Hornsey Town Hall

TITLE: Courtyard B Layout

SCALE AT A3: 1:20 (U.N.O)	DATE: 16.02.2021	DRAWN: LF	CHECKED:
PROJECT NO: HTH-20.03	DRAWING NO: GSL-CY-001	REVISION:	C02

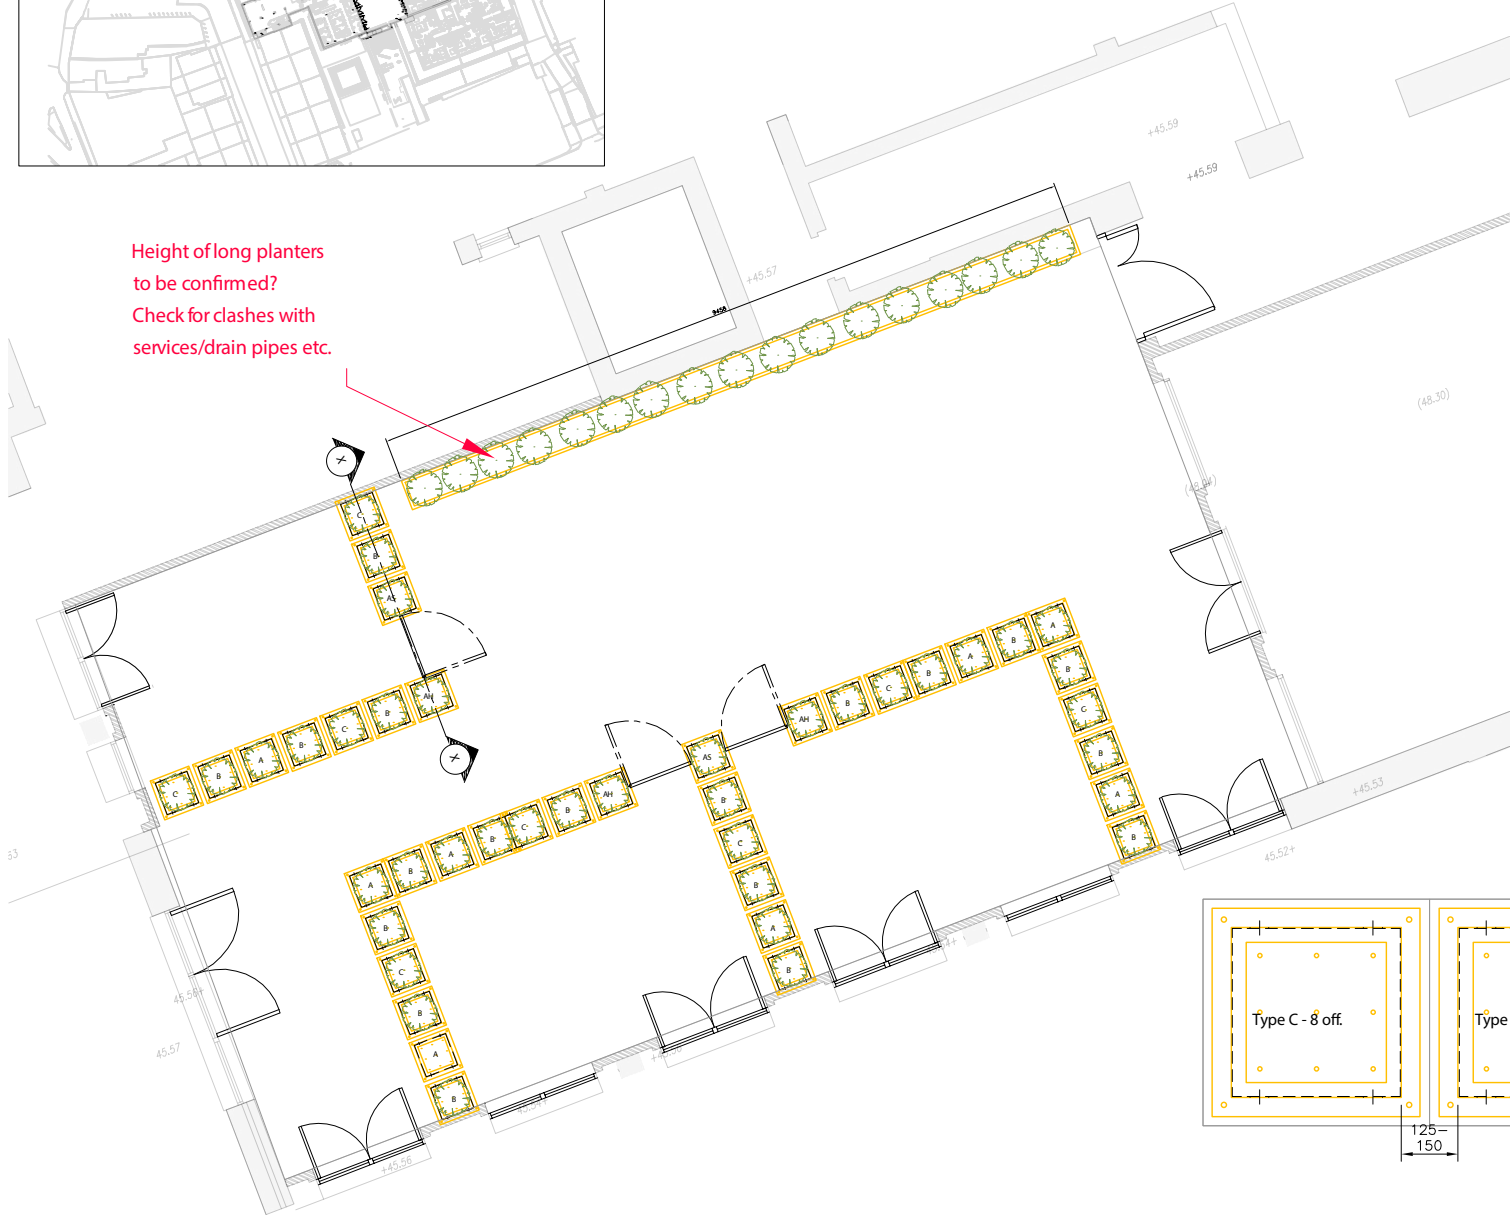
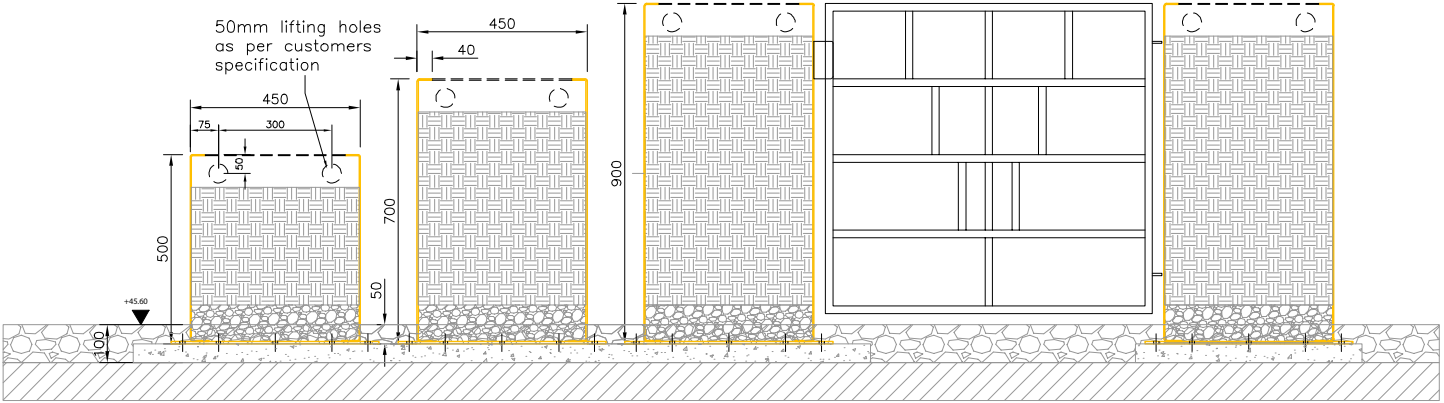
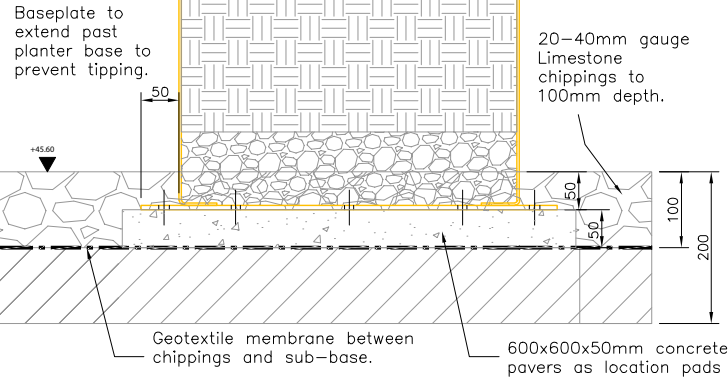
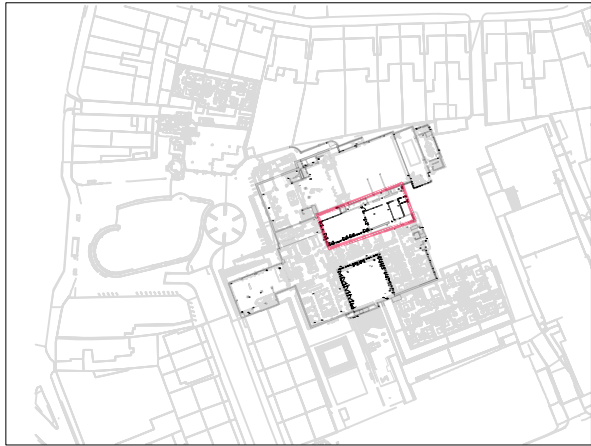
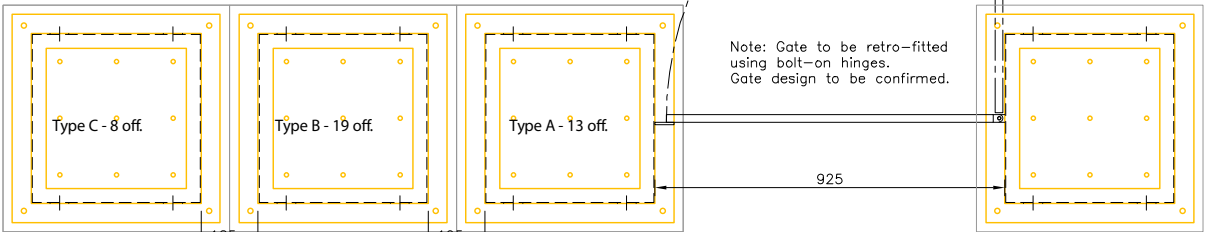
Height of long planters
to be confirmed?
Check for clashes with
services/drain pipes etc.
